Phase One, Building 1a
Construction Document Phase.
(ARCHITECTURAL DRAWINGS)

CD 100%	09/30/2010	FOR REVIEW
DD 100%	05/26/2010	FOR REVIEW

DETAIL

LD-06

D-04 **DETAIL**
LD-03 **SCALE: 1:20**

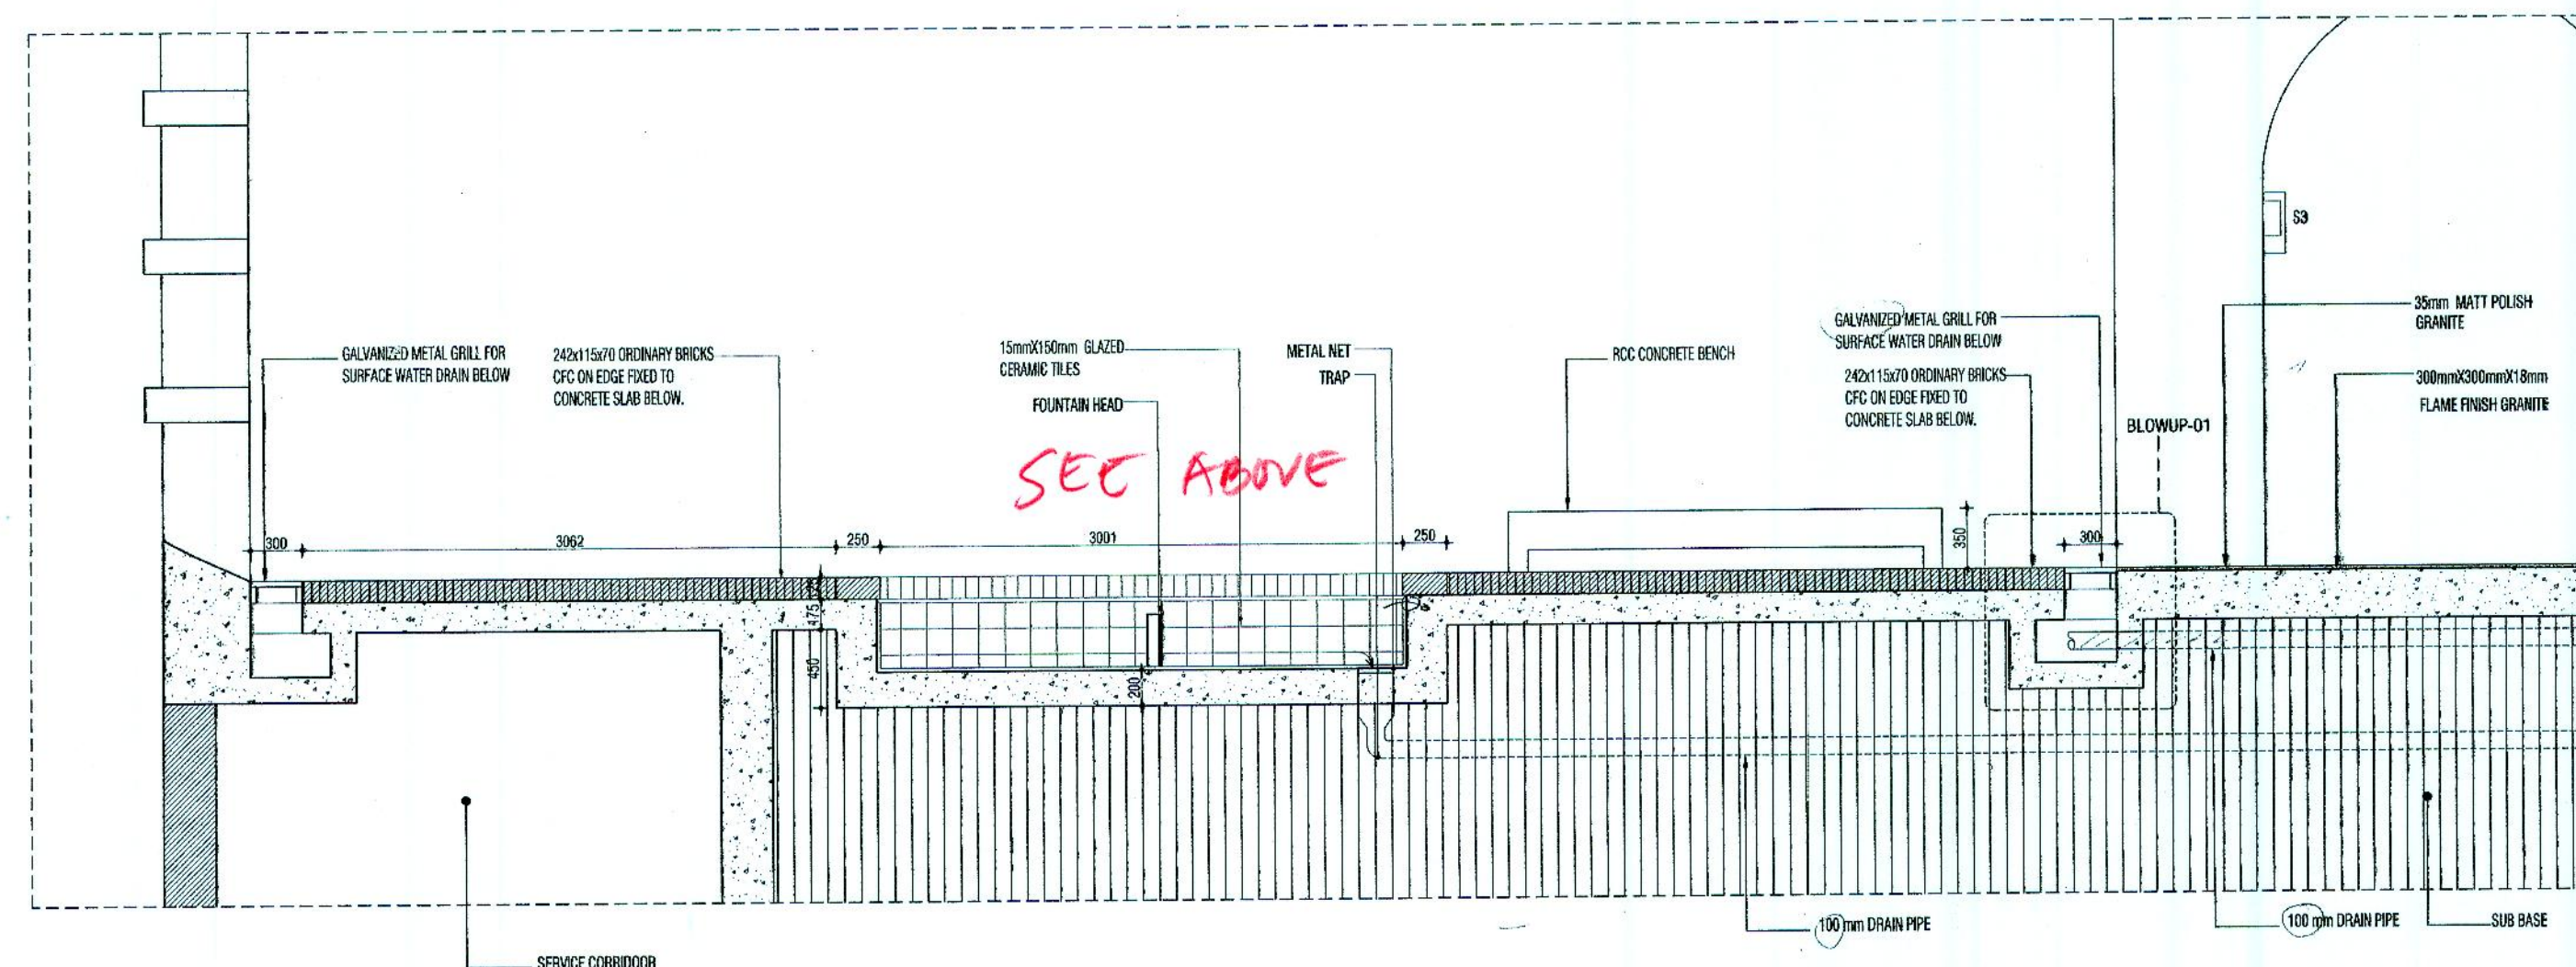
POOL EDGE MATERIAL
TO BE DETERMINED

SKIMME
(DISCREET
ACCESS
NEEDS
STUDY)

NOTE: FOUNTAINS SHOULD HAVE PLUMBING EQUIPMENT THAT INCLUDES SKIMMER @ WATER LEVEL, OVERFLOW @ WATER LEVEL, LIGHTS. IF "WHITE WATER" FOUNTAIN DISPLAY (AT FOUNTAIN HEAD) - TOP OF HEAD NEEDS TO BE BELOW WATER LEVEL - AS SHOWN, THERE SHOULD BE A MEANS OF DRAINING THE FOUNTAIN. THERE SHOULD ALSO BE A SUCTION RETURN LINE AT THE BOTTOM

NOTE: SIZE OF POOL
MAY DICTATE IF MORE
THAN 1 OF THESE COMPONENTS
IS REQUIRED - CONSULT FOUNTAIN
EQUIP MFG OR CONSULTANT,
ALL VISIBLE METAL SHOULD BE BRONZE
OR BLACK STAINLESS STEEL. ALSO SKIMMER(S)
ARE OFTEN POSITIONED AS RELATED TO
WIND OR CURRENT - IN ORDER TO
COLLECT DEBRIS.

IRRIGATION over
STRUCTURE?

BLOWUP-01
SCALE: 1:10

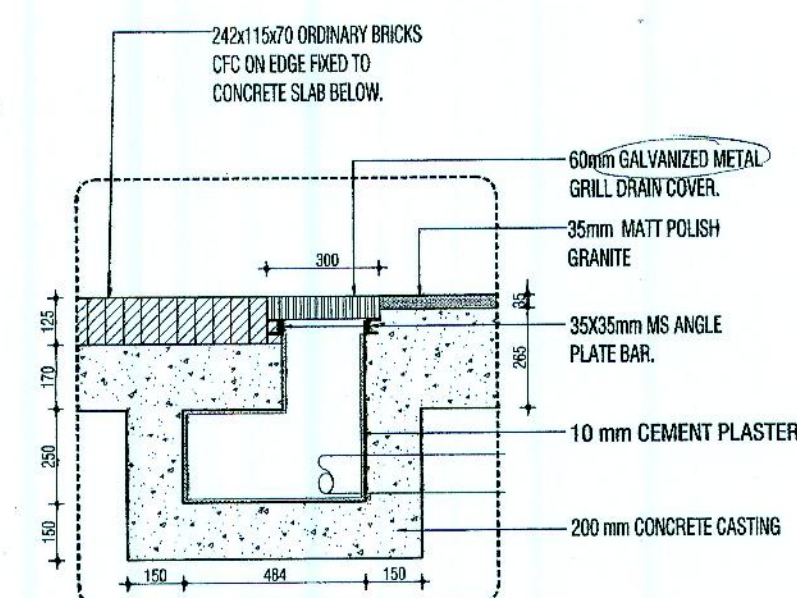
NOTE 8!

SEE ABOVE
